PLANNING COMMISSION AGENDA
August 11, 2011
7 p.m. Regular Meeting
Newberg Public Safety Building
401 E. Third Street

TYPE III HISTORIC LANDMARK MODIFICATION/ DESIGN REVIEW/VARIANCE STAFF REPORT Chehalem Cultural Center Parking Lot

REQUEST: Historic landmark modification review and design review for a new parking lot. Variance review to reduce the front yard setback from 25 feet to 7 feet on the north side, and 14 feet on the west side.

EXHIBIT C: LANDSCAPING PLAN
 HISD-11-003/DR2-11-010/VAR-11-002
 CHEHALEM CULTURAL CENTER – PARKING LOT

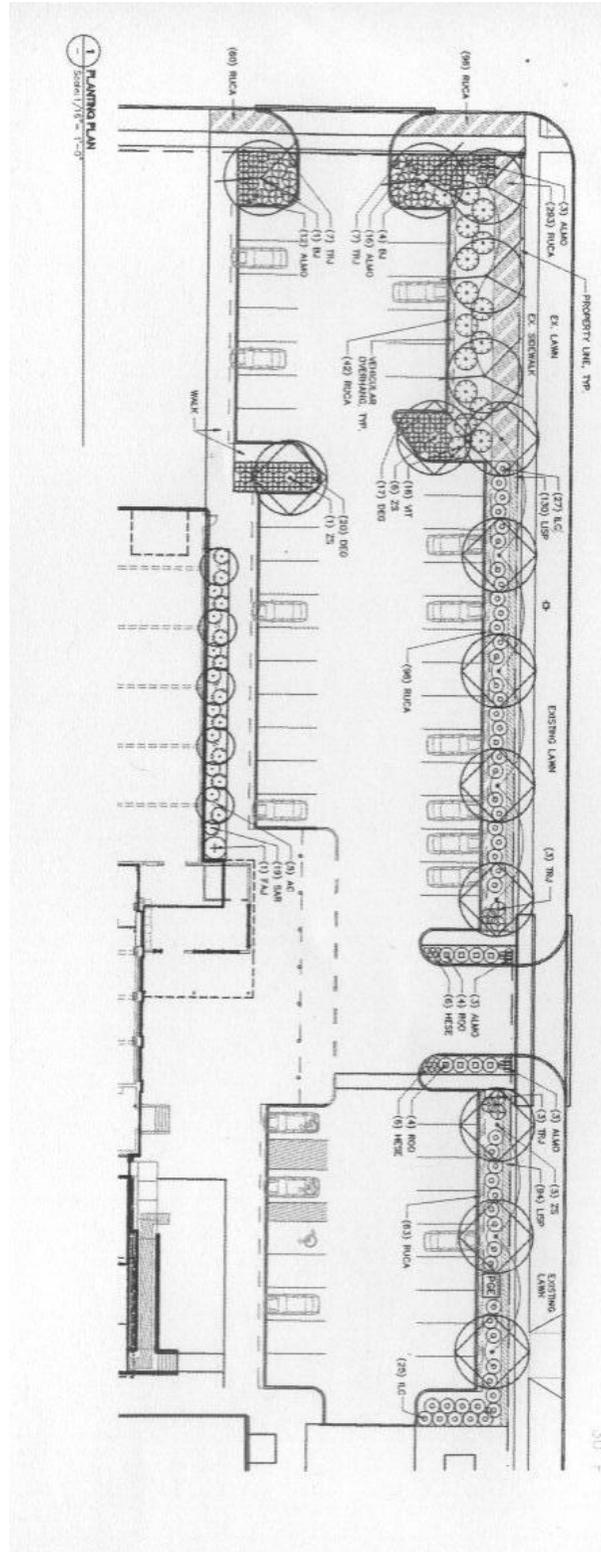
Finding: The landscaping standards require a parking lot tree for every seven spaces. The parking lot trees can be in islands or in a row across the head of the parking spaces. Most of the proposed landscaping plan meets this standard. The landscaping plan needs to add one additional parking lot tree to the southeastern row of spaces near the building.

The landscaping standards require street trees every 35-40 feet, with a minimum 1.5-1.75 inch caliper trunk. If the planter strip along Sherman Street was going to be removed in Phase Two to build on-street angled parking then street trees would not be required. It has been determined by staff that it is unlikely that angled parking will be built along Sherman Street, so the landscaping plan

should be modified to add street trees in the Sherman Street planting strip. The street trees could be staggered with the location of the parking lot trees.

- Method of irrigation
 - Add one additional parking lot tree to the southeastern row of spaces near the building
 - Add street trees in the Sherman Street planting strip. The street trees could be staggered with the location of the parking lot trees

GRADING AND
DRAINAGE PLAN

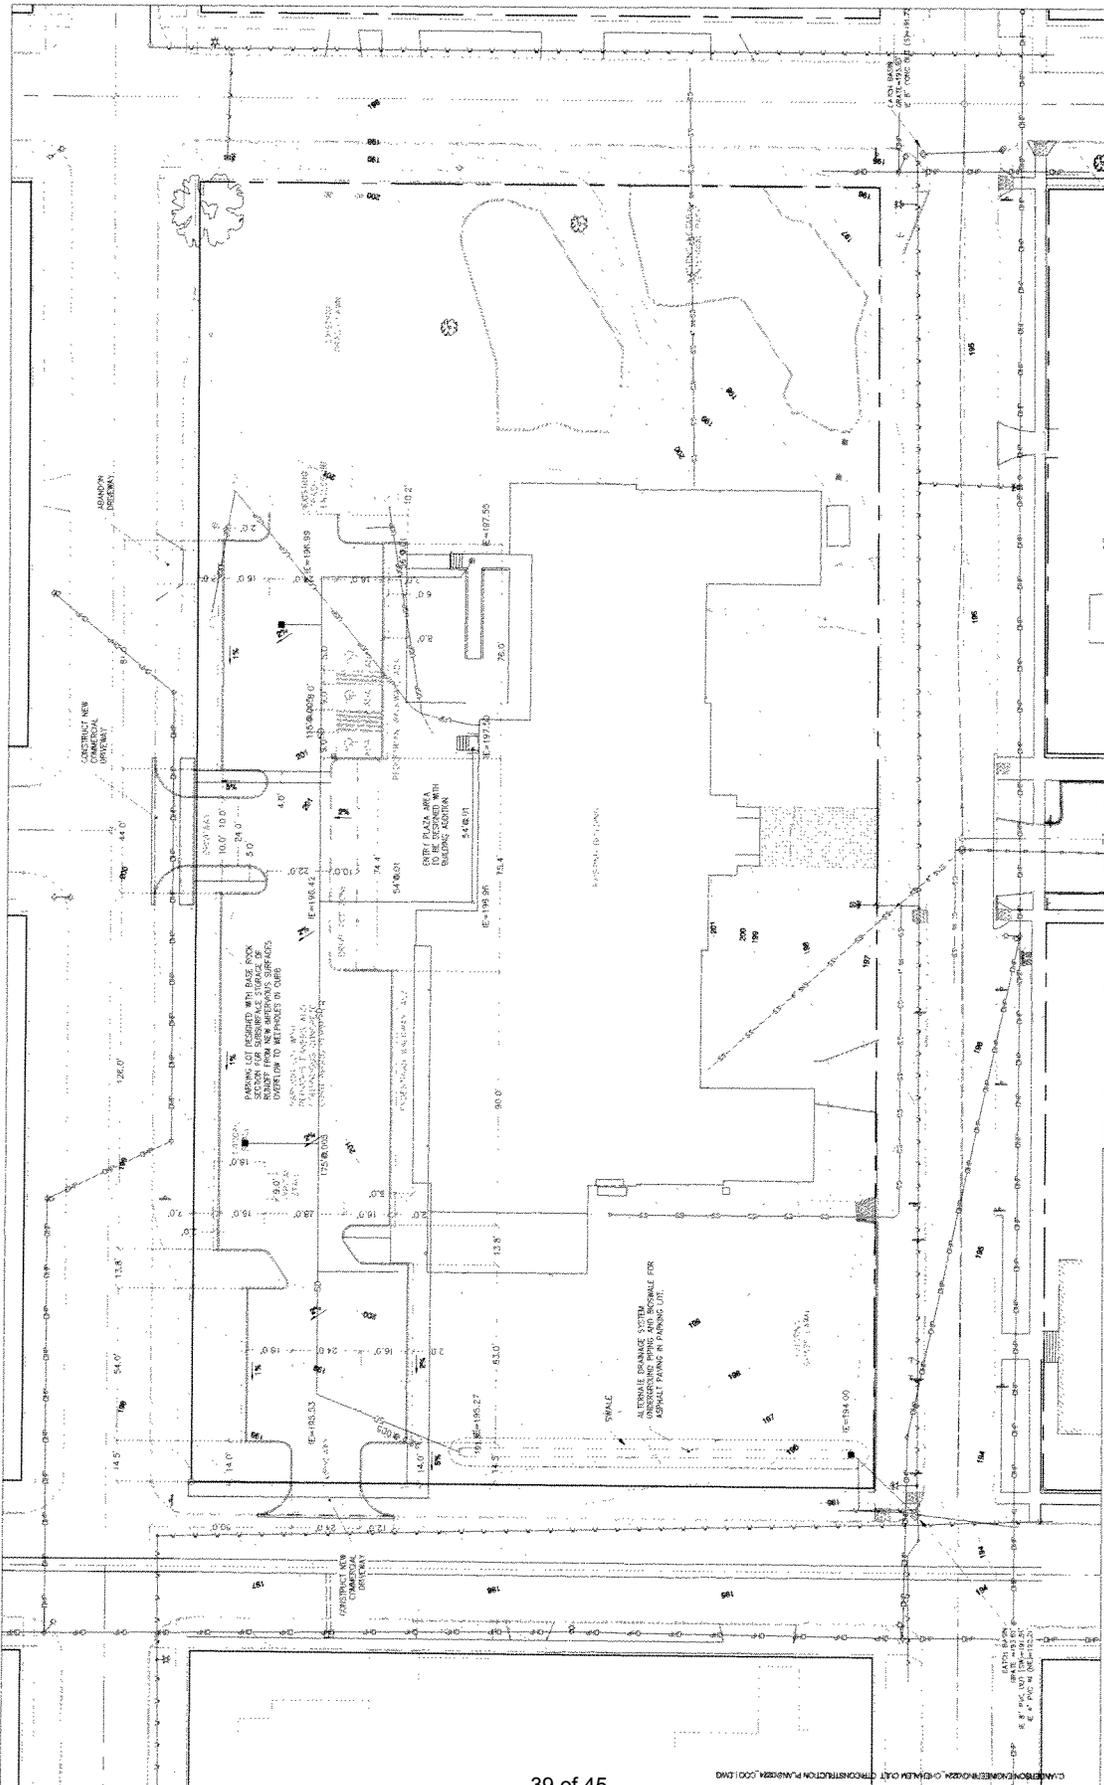
- Install ADA ramps on sidewalk at both driveways.
- Remove and replace abandoned driveway and apron in the public right of way with standard curb, gutter and sidewalk.
- Inlet at outlet of swale needs to be a ditch interceptor (DI).

- Pipe sizes need to be shown. Show pipe size of line from DI to CB on Blaine.
- Provide detention or show that the stormwater flow offsite is not greater than the current conditions.

- Pipe sizes need to be shown. Show pipe size of line from DI to CB on Blaine.
 - Provide detention or show that the stormwater flow offsite is not greater than the current conditions.
